ATB 50988 (1402)

MIL Comes On With DTC P0455 and/or P0456

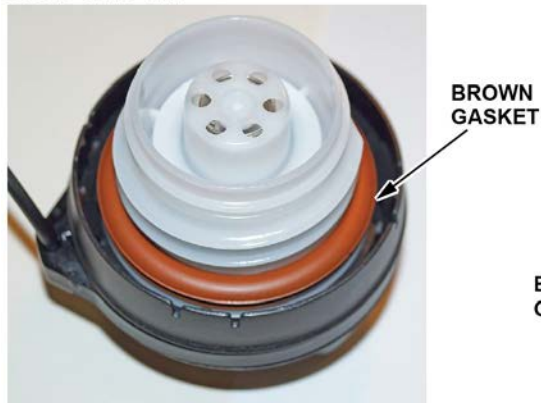
1. Confirm that DTC P0455 and/or P0456 is stored.
 - If DTC P0455 and/or P0456 is stored, go to step 2.
 - If neither DTC P0455 nor P0456 is stored, this bulletin does not apply. Continue with normal troubleshooting.
2. Remove the fuel fill cap and inspect the gasket.
 - If the gasket is black, go to REPAIR PROCEDURE.
 - If the gasket is brown, the fuel fill cap has already been replaced. This bulletin does not apply. Continue with normal troubleshooting.

Replace the fuel fill cap with a new one that has a brown gasket.
